Re: Draft Plan of Subdivision: Menzie Enclaves
County of Lanark Fileno# 09-T-23006

RESPONSE TO AGENCY COMMENTS

MENZIE ENCLAVES SUBDIVISION

DRAFT PLAN OF SUBDIVISION OPTION 3

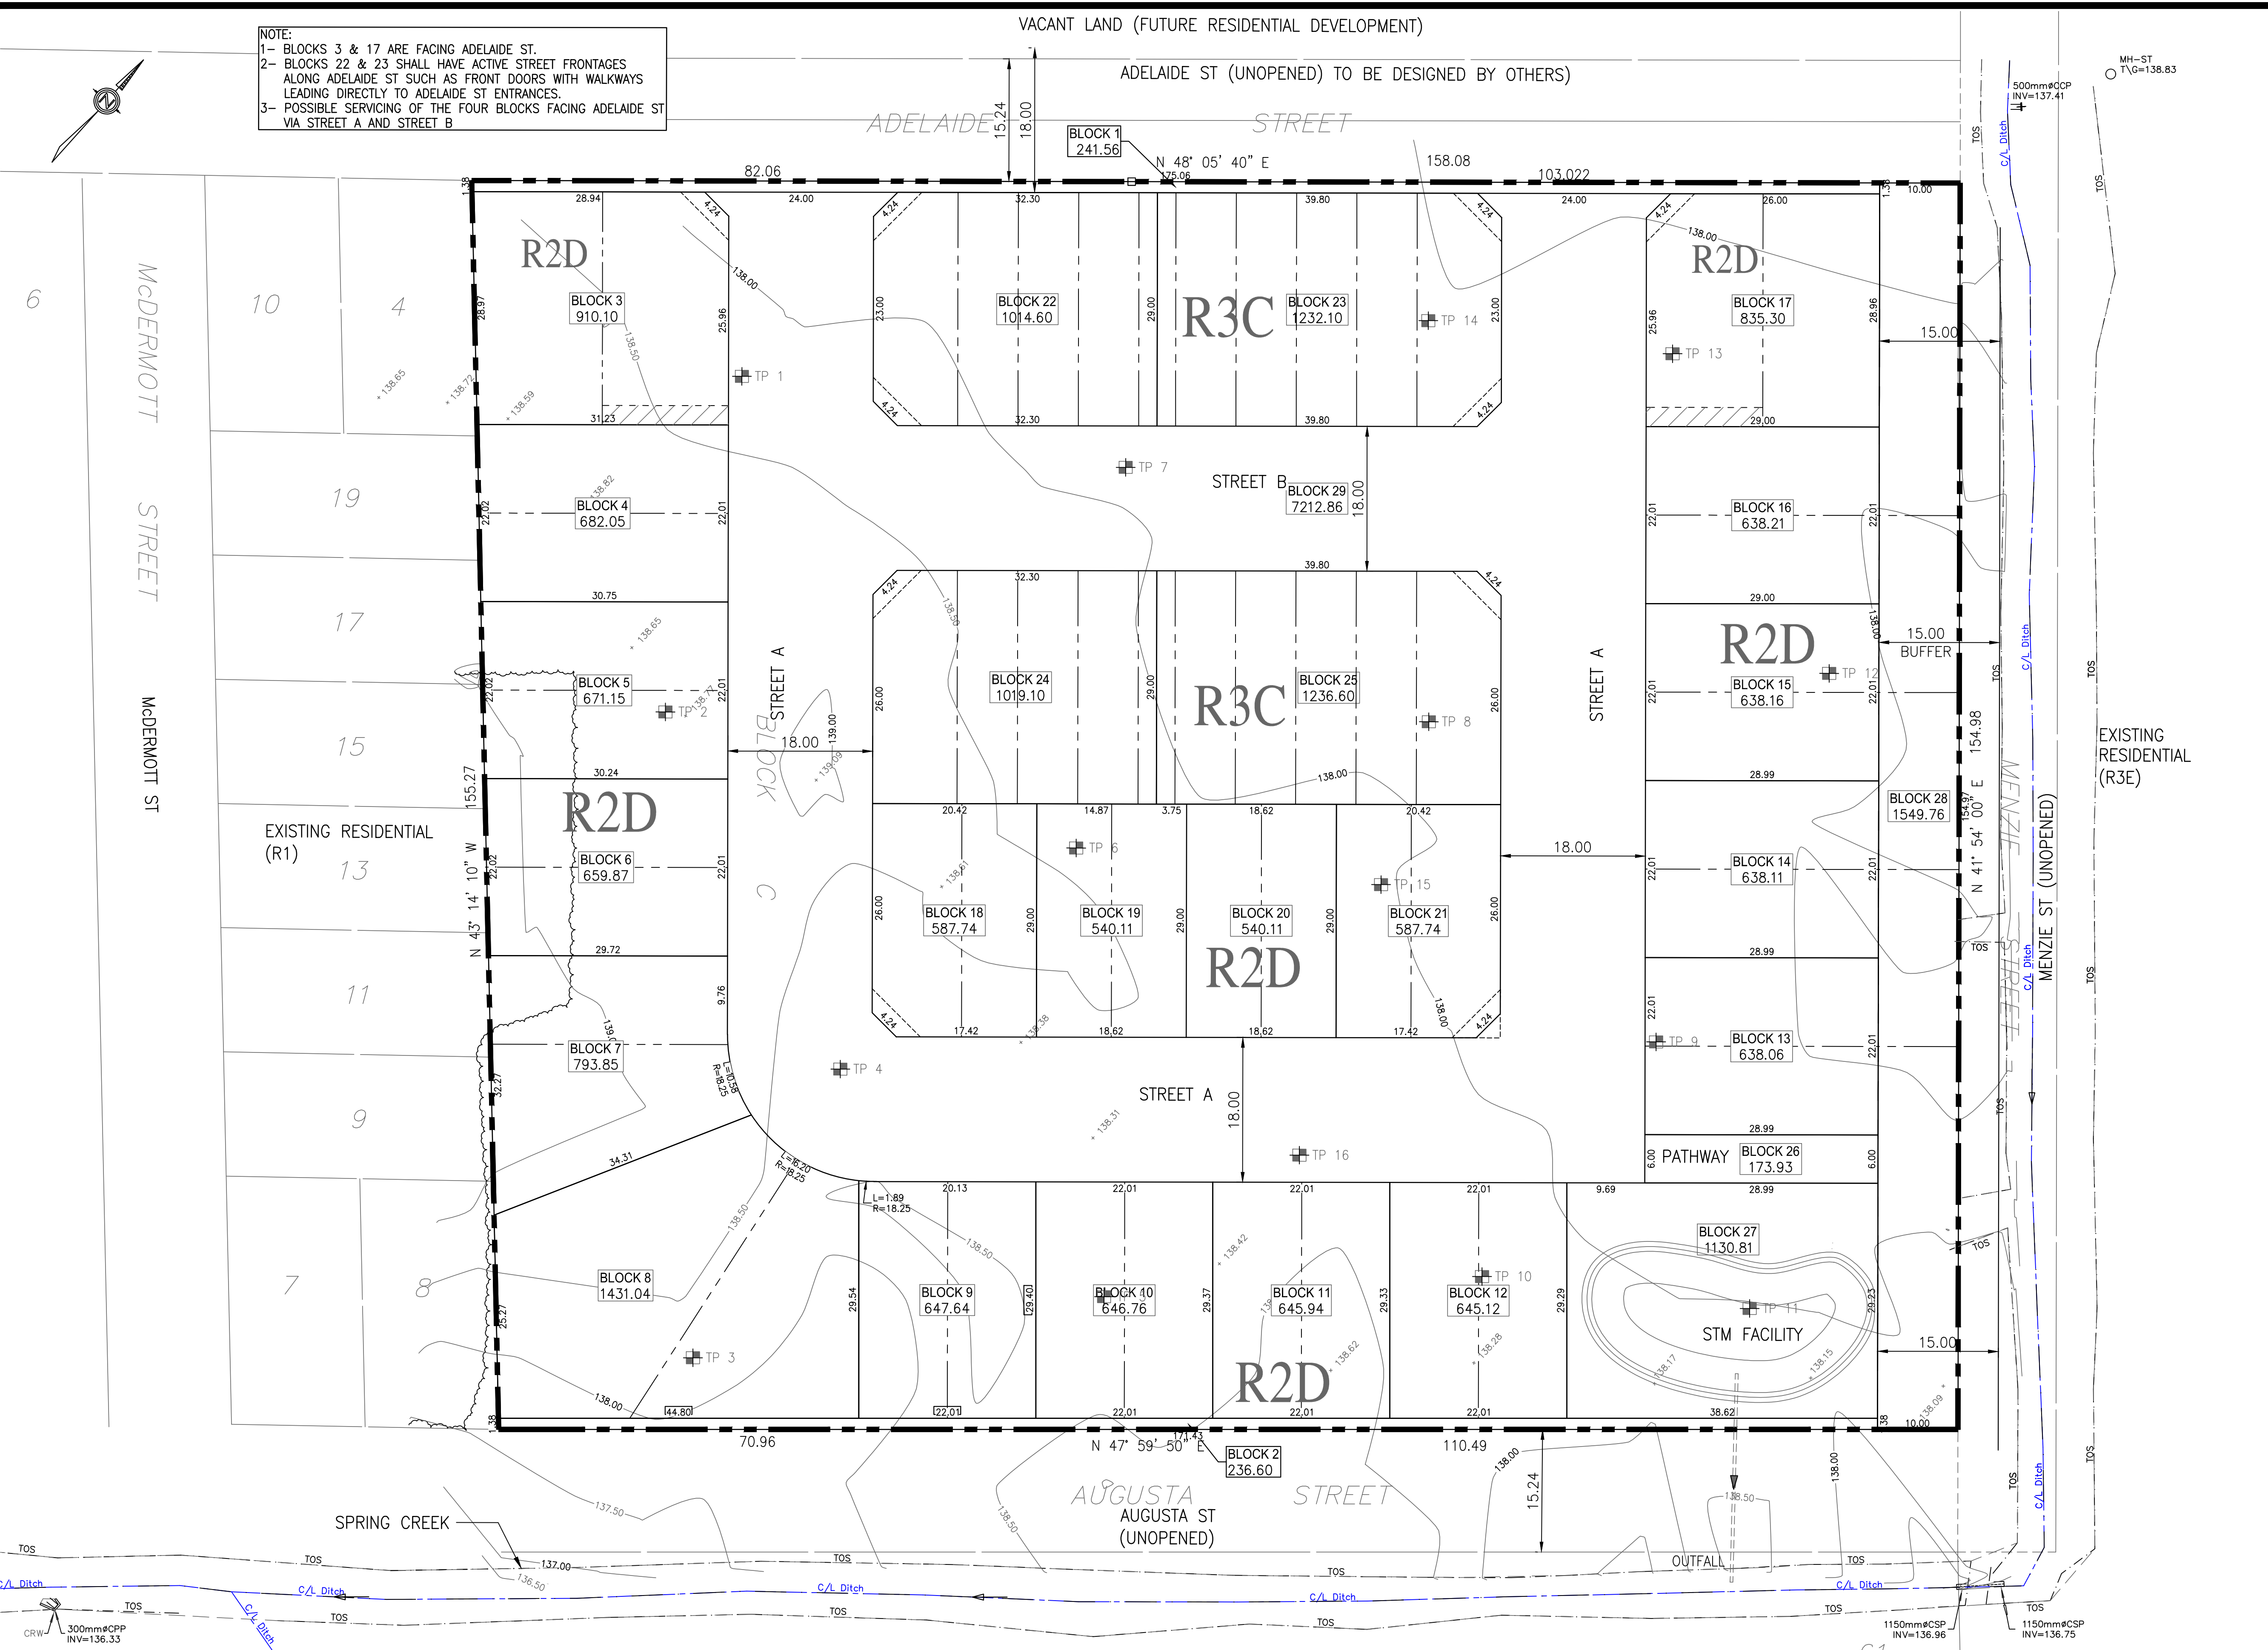
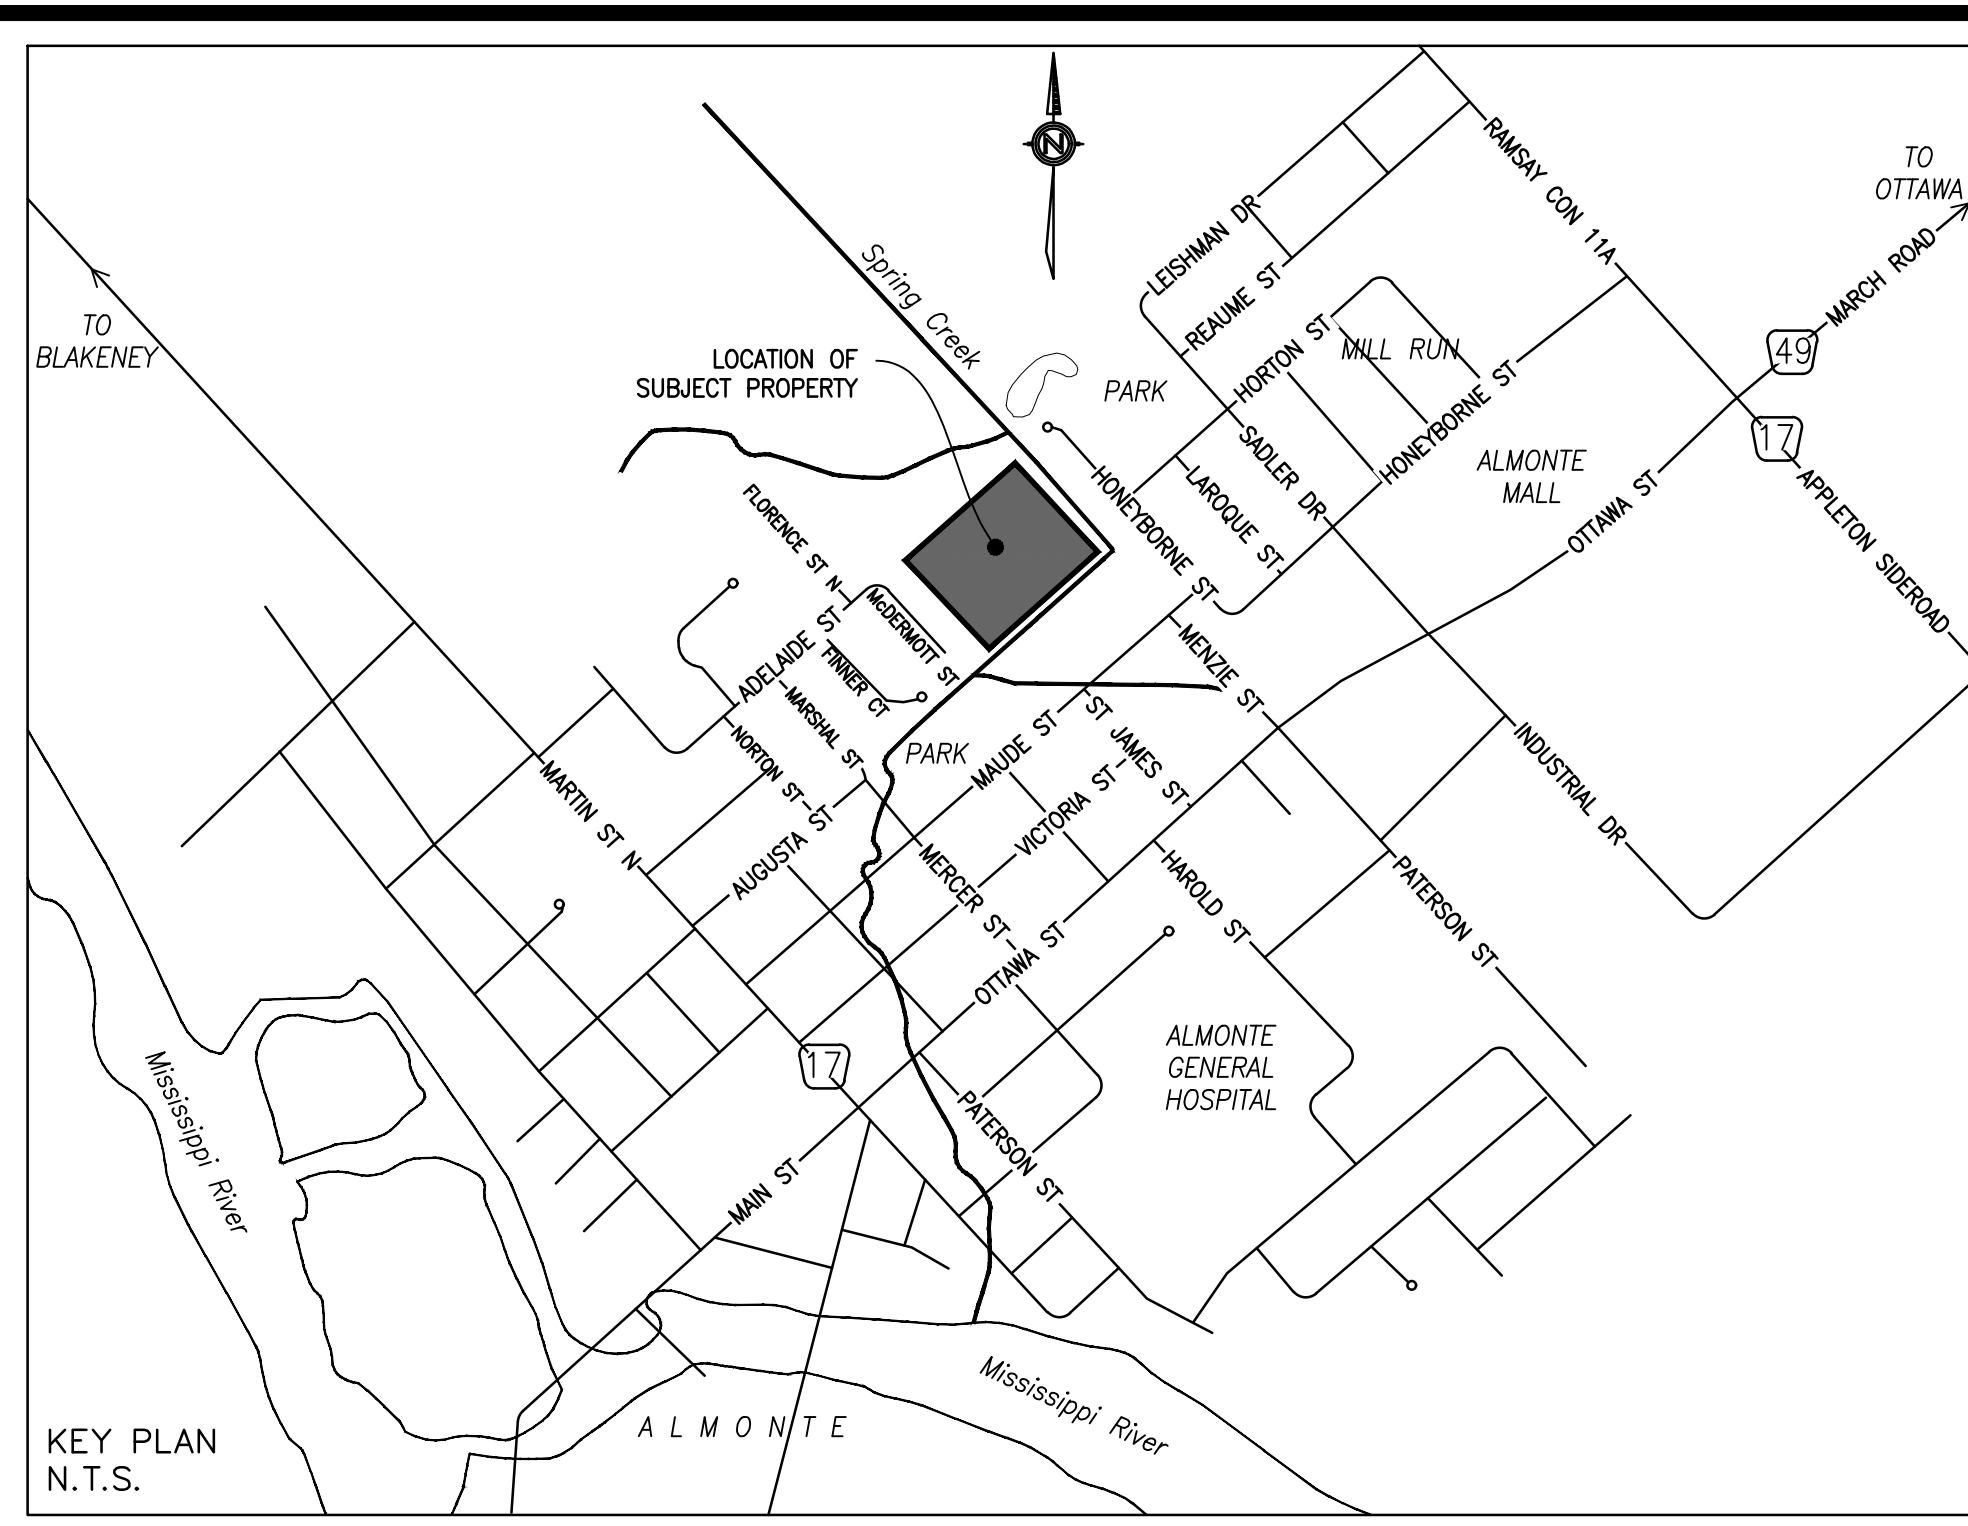
ANNEX I: Modified Plan as now accepted by Melanie Knight indicating subdivision modified per density targets and other requirements namely the façade of units on Adelaide street to face the street. Full scale plan to be expedited under separate cover via mail.

2. Based on the site plans for the townhomes, it appears that the design of the rear yards fronting onto Adelaide is a typical rear yard with no pedestrian connections to Adelaide Street. Consider flipping the orientation of the townhouses so that units front onto Adelaide Street and the rear of the units back onto Street B.

NOTE:
 1- BLOCKS 3 & 17 ARE FACING ADELAIDE ST.
 2- BLOCKS 22 & 23 SHALL HAVE ACTIVE STREET FRONTS ALONG ADELAIDE ST SUCH AS FRONT DOORS WITH WALKWAYS LEADING DIRECTLY TO ADELAIDE ST ENTRANCES.
 3- POSSIBLE SERVICING OF THE FOUR BLOCKS FACING ADELAIDE ST VIA STREET A AND STREET B

AE: There is a pedestrian connection for the townhouses to Adelaide St. We will make the principal elevation the one facing Adelaide and the driveway and services will be accessible from Street B.
